**PLANNED UNIT DEVELOPMENT  
& SUBDIVISION STAFF REPORT****Date: May 19, 2011****DEVELOPMENT NAME**

Maryland &amp; Franklin Subdivision

211 South Franklin Street  
(East side of Franklin Street, 155'± North of Virginia Street  
and extending East to South Conception Street)

Planned Unit Development Approval to allow shared  
access between three building sites, and Subdivision approval to create 3 lots.

# SITE PLAN

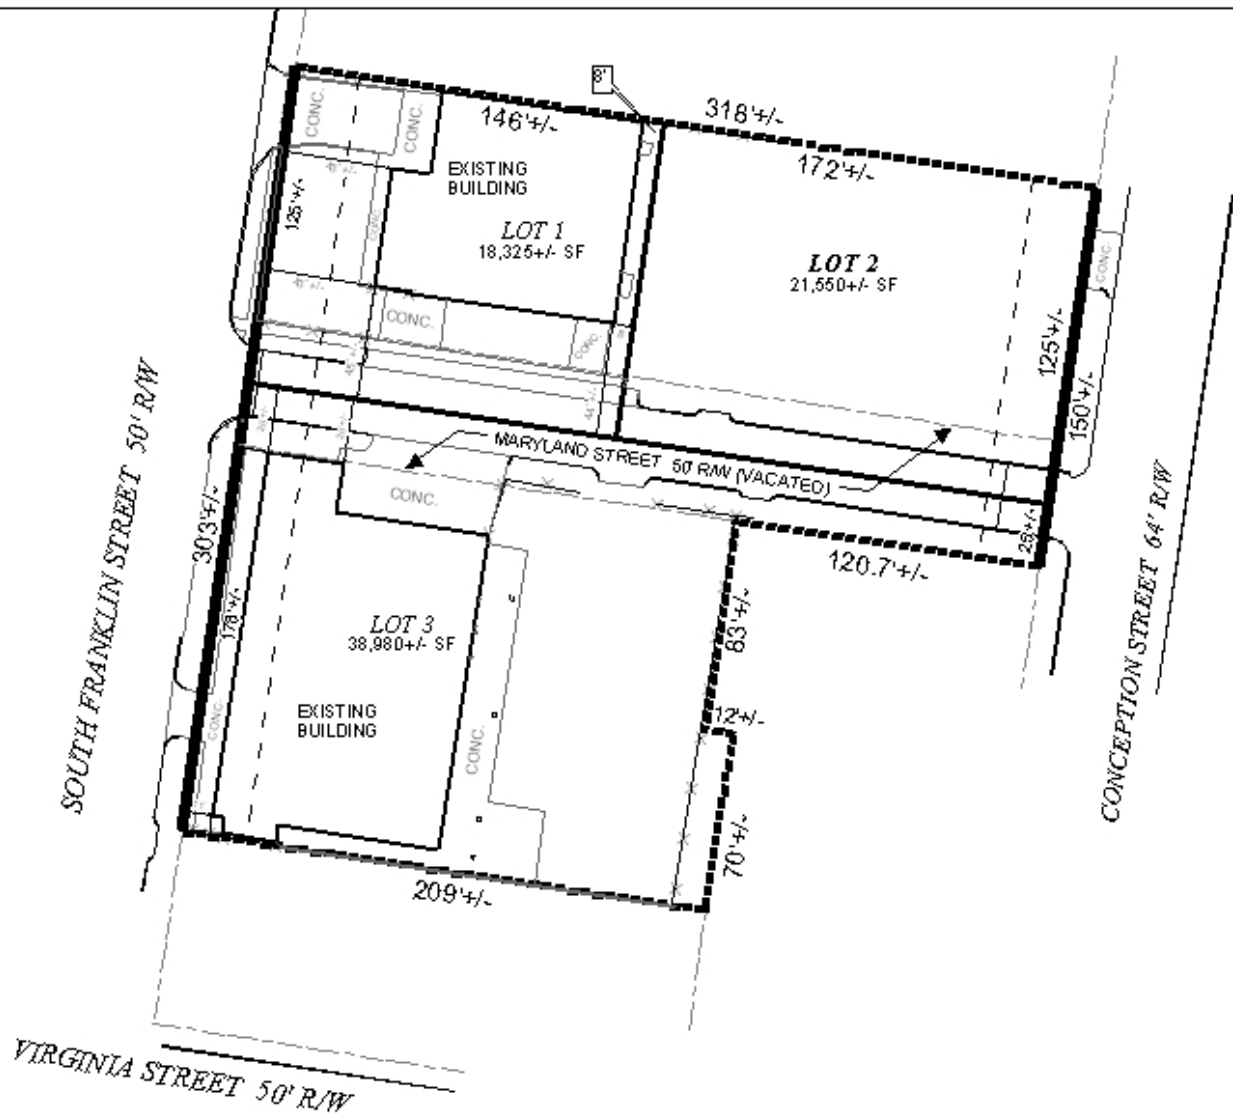
The site is zoned I-1, Light Industry District, and the proposed Lot 1 and Lot 3 are currently developed. The PUD site plan does not indicate parking calculations, parking areas, dumpster locations (if any), trees, fencing, or any landscaping the site. As such, it is impossible to evaluate the PUD request until a proper site plan showing all site improvements and features, as well as parking calculations and parking areas, is submitted.

- 1) submit an accurate site plan illustrating all site improvements and features (dumpster locations (if any), trees, fencing, or any landscaping the site), as well as parking calculations and parking areas.

*The applicant provided a revised PUD site plan, however, after further meetings and discussions with the applicant, it was determined that the provided site plan was not adequate for the applicant's needs. As such, the applicant has requested a holdover to the June 16, 2011, meeting in order for them to develop a site plan that incorporates all of their needs on the site.*
